Department	Customer Service	
Category	Product Recall	
Title	T300 Horton Fan Hub	
Number	03KW9	
Initial Release Date	10/15/03	Page 1 of 3
Revision Date

FEDERAL RECALL CAMPAIGN 03KW9

T300 MODELS BUILT AT THE STE. THERESE FACTORY SEPTEMBER 1, 2002 THROUGH SEPTEMBER 26, 2003 WITH CAT C7 & 3126E ENGINE & HORTON DRIVEMASTER FAN HUB

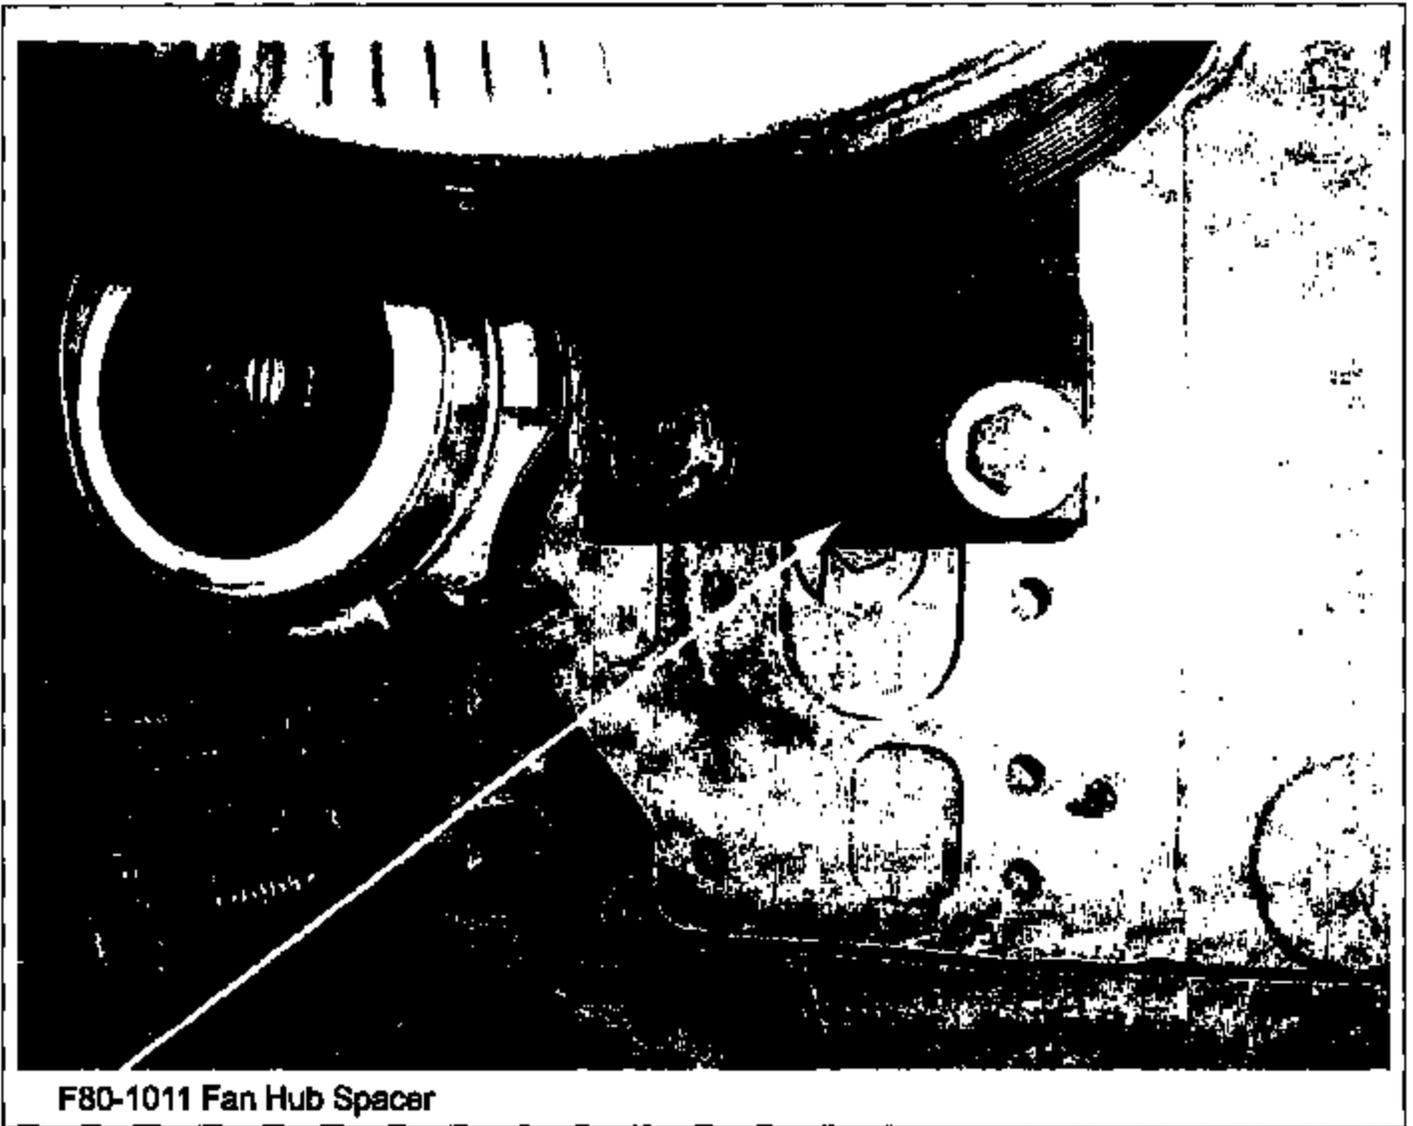
5. Re-install original fan hub if not damaged or new fan hub using new fasteners per the following:

CAUTION: Torque bolts to: 37 +/- 2 lbs-ft using a calibrated torque wrench. Applying a torque outside of this range can either cause the bolt to fall or allow the bolt to loosen.

NOTE: Apply Loctite 2440 to each bolt prior to installation.

- Upper Mounting Holes

Quantity	Part Number	Description
2	W34-1009	Washer
2	W34-1070-030	Bolt - M8 X 1.25

- Lower Mounting Holes

Quantity	Part Number	Description
1	F80-1011	Fan Hub Spacer (See <u>Figure 1</u> on page 3.)
2	W34-1009	Washer
2	W34-1070-040	Bolt - M8 X 1.25
